**RE: Chelwood Apartments  
900 & 901 Chelwood NE  
Grading and Drainage Plan & Drainage Report  
Engineer's Stamp Date: 08/10/19  
Hydrology File: J22D070**

**RE: Chelwood Apartments  
Grading and Drainage Plan & Drainage Report  
Engineer's Stamp Date: 02/06/19  
Hydrology File: J22D070**

Based upon the information provided in your submittal received 02/08/2019, the Grading & Drainage Plan and Drainage Report **is not** approved for Building Permit and Grading Permit. The following comments need to be addressed for approval of the above referenced project:

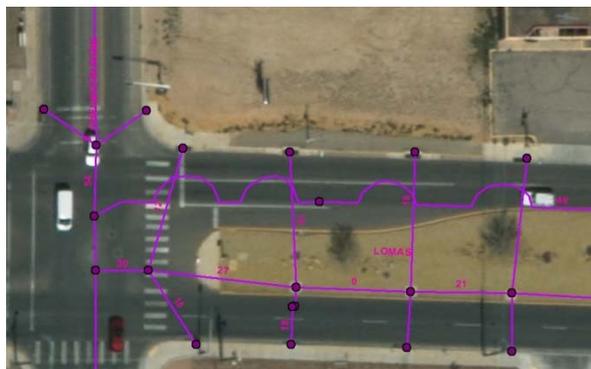
1. Since there are improvements within the two alleys associated with this development, these improvements will be required to be placed on an Infrastructure List. The Infrastructure List must be tied to a Site Plan for Building Permit and requires action by the DRB. Therefore this project is a DRB site which has a higher standard review fee. Because this was submitted as an Admin site, a deficit submittal fee of \$300 is due. **site is going administratively for approval with no infrastructure list**
2. Please use the recorded plat which was approved in December 2018. Also show all easements. **corrected**
3. Please remove the storm sewer behind the curb along Lomas and the two MHs within the existing asphalt sidewalk. This storm pipe is not part of the GIS as-builts (see image) and the two MHs do not exist in the field. **removed**

<b>CHELWOOD APARTMENTS</b> <b>GRADING AND DRAINAGE PLAN</b>	DRAWN BY: WCWJ DATE: 6-18-19 218149-LAYOUT-6-18-19
		SHEET # — JOB # 218149

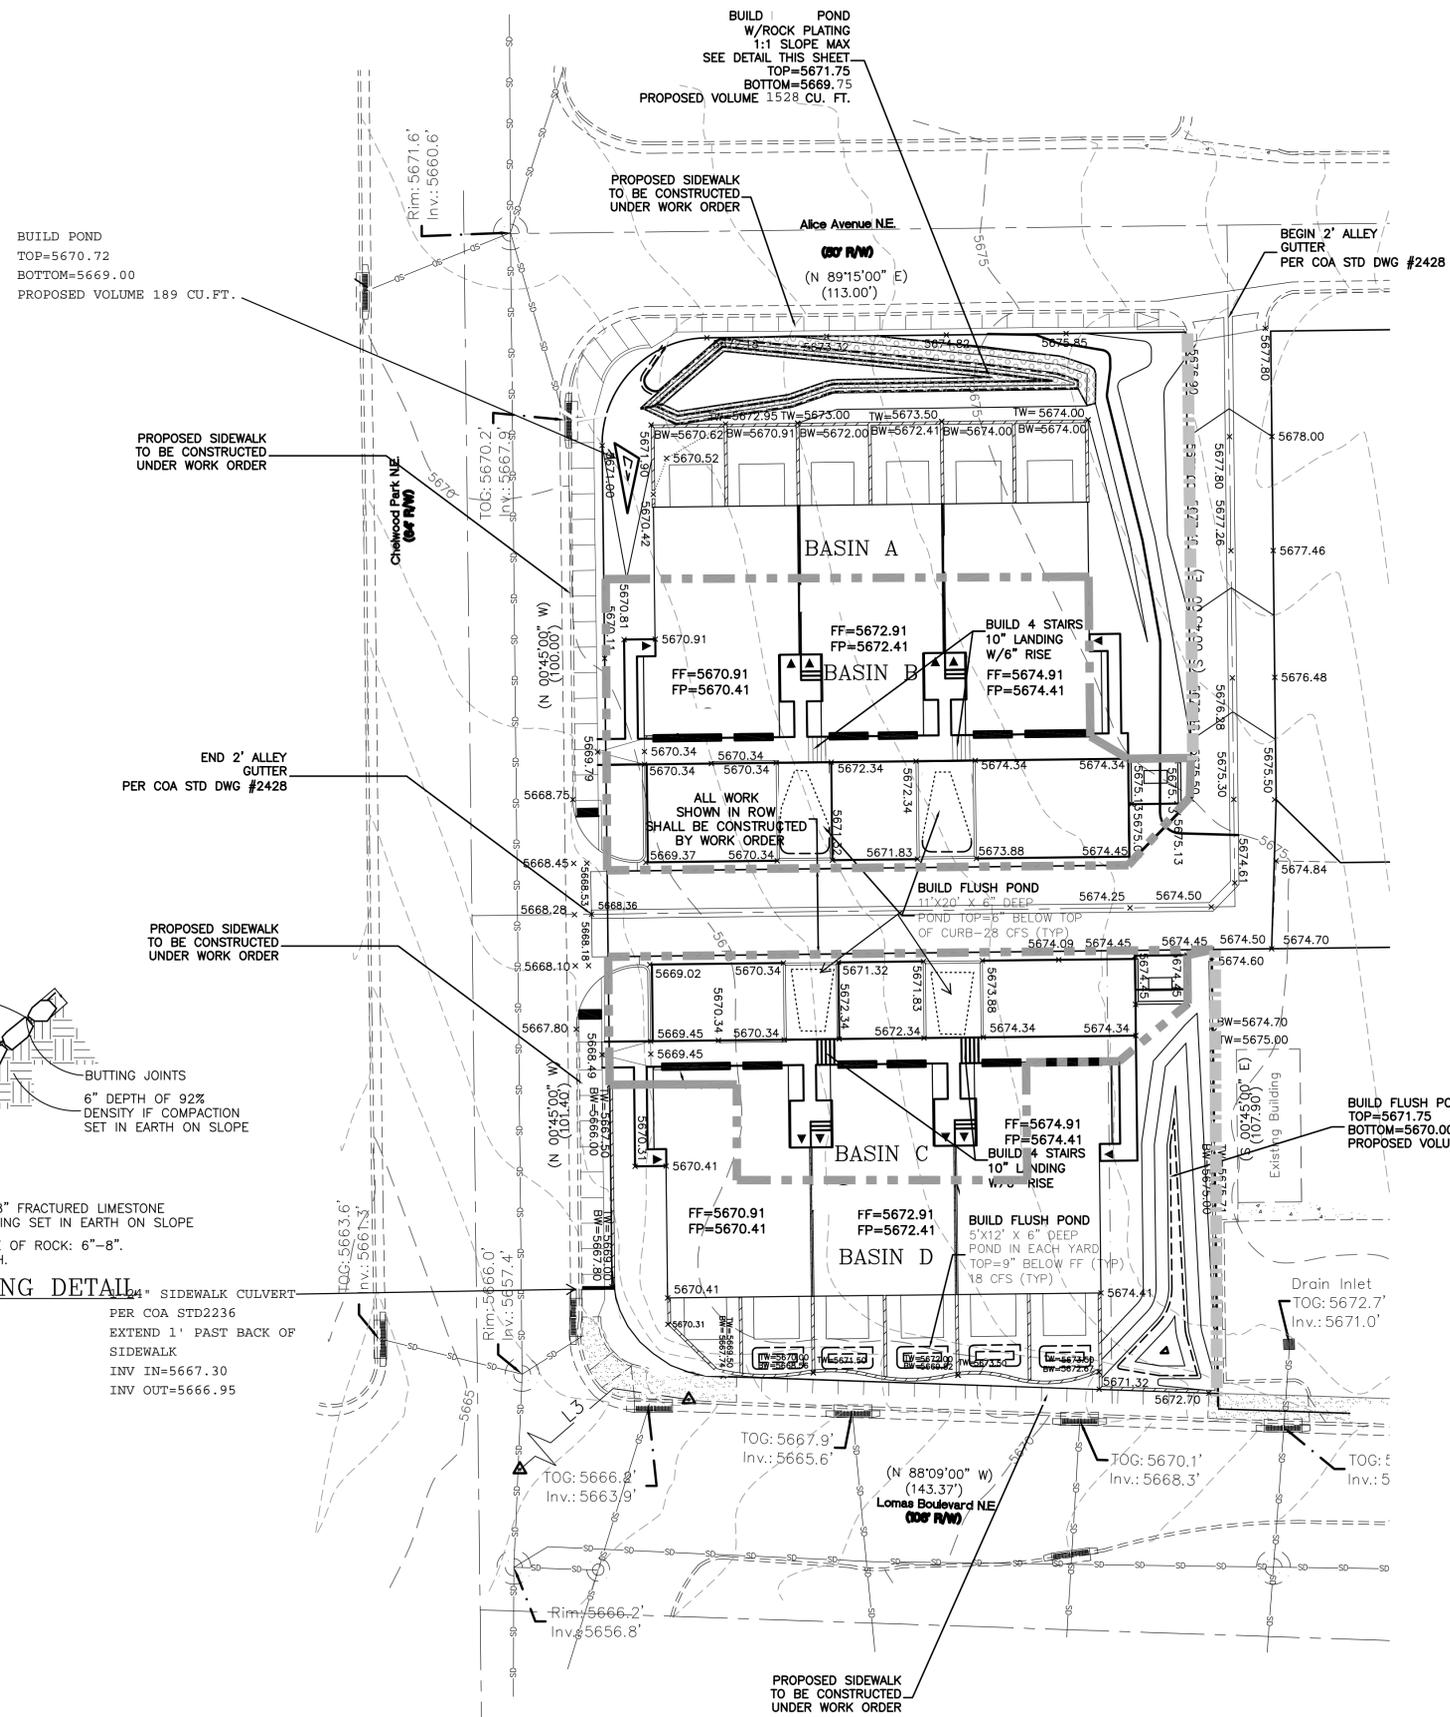
4. Please label the proposed sidewalks and improvements within the two alleys to be built with a work order. **added labels**
5. Please check with Transportation if the existing asphalt sidewalk along Lomas needs to be replaced to City standards. **we have identified this as to be constructed**

6. Please add a typical section through the ponds at Chelwood Park showing the R.O.W., existing road payment, proposed sidewalk, proposed retaining wall with the location of the footer (see comment #7), and the proposed building. **section added**

8. Please show the alley gutter per City Drawing #2411 & 2415. Grading within the alleys must also follow these standard drawings. **added notes**
9. Please show the flowline elevations of the alley gutter at the ends where it will tie into existing grades and at the intersection of the two alley gutters. **added spots**

10. Are there emergency spillways for the overflow of the two ponds along Chelwood Park to enter into the street curbing through sidewalk culverts? Or is the piping into the existing inlets have sufficient capacity for the overflow? Please verify. **we understand emergency spillways are allowed to pass over sidewalks**
